Intel® I/O Controller Hub 7 (Intel® ICH 7) Family

Specification Update

September 2013

Figure 23-21: G3 (Mechanical Off) to S0 Timings (Mobile/Ultra Mobile Only)

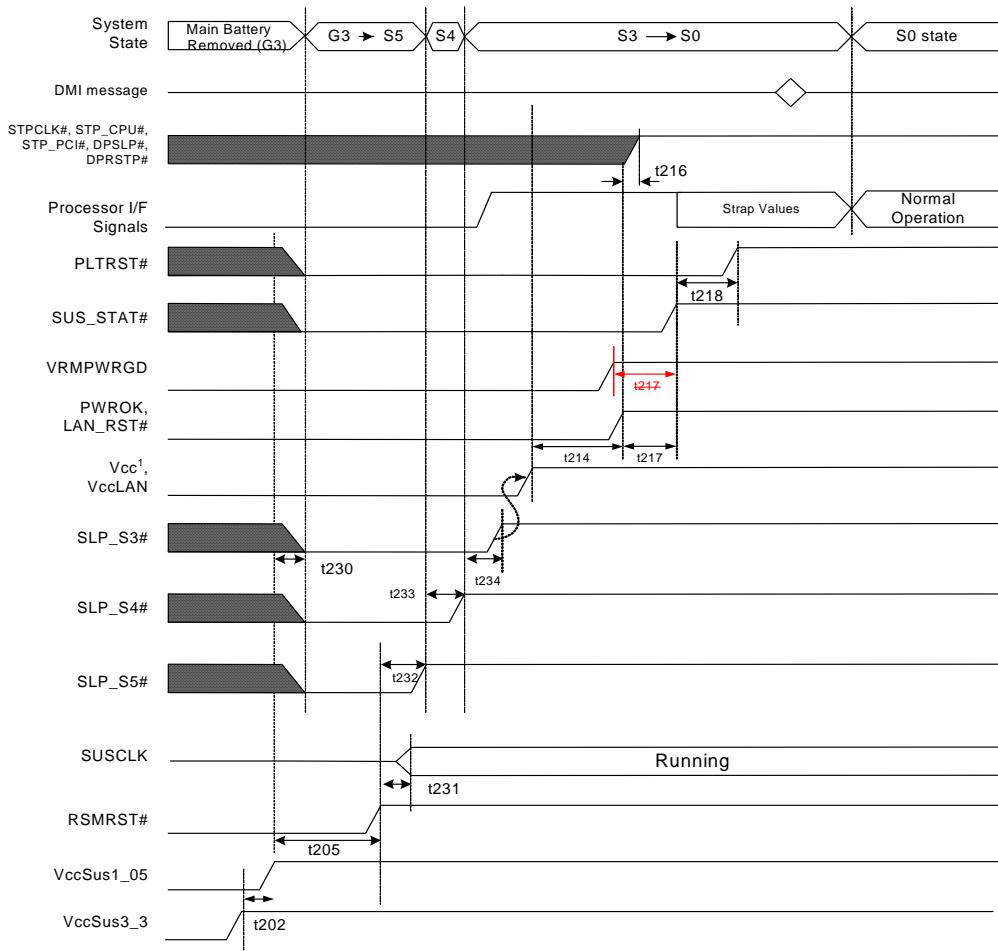
6. Remove t217 timing from Figure 23-21

Remove t217 timing that points from VRMPWRGD going high to SUS_STAT# going high from Figure 23-21: G3 (Mechanical Off) to S0 Timings (Mobile/Ultra Mobile Only) in the Datasheet.

Figure 23-25 S0 to S5 to S0 Timings, S3_cold (Mobile/Ultra Mobile Only)

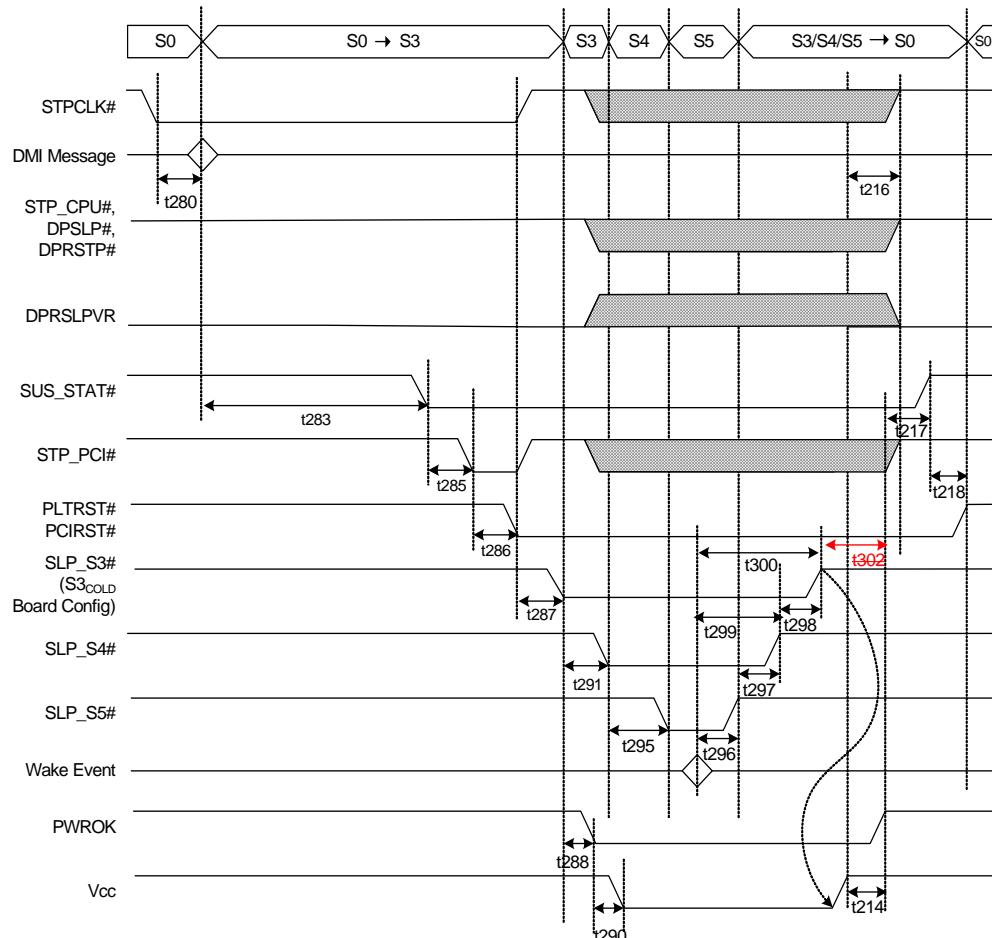
Remove t302 timing requirement from Figure 23-25

Remove the t302 timing requirement from Figure 23-25 S0 to S5 to S0 Timing, S3_cold (Mobile/Ultra Mobile Only) in the Datasheet.
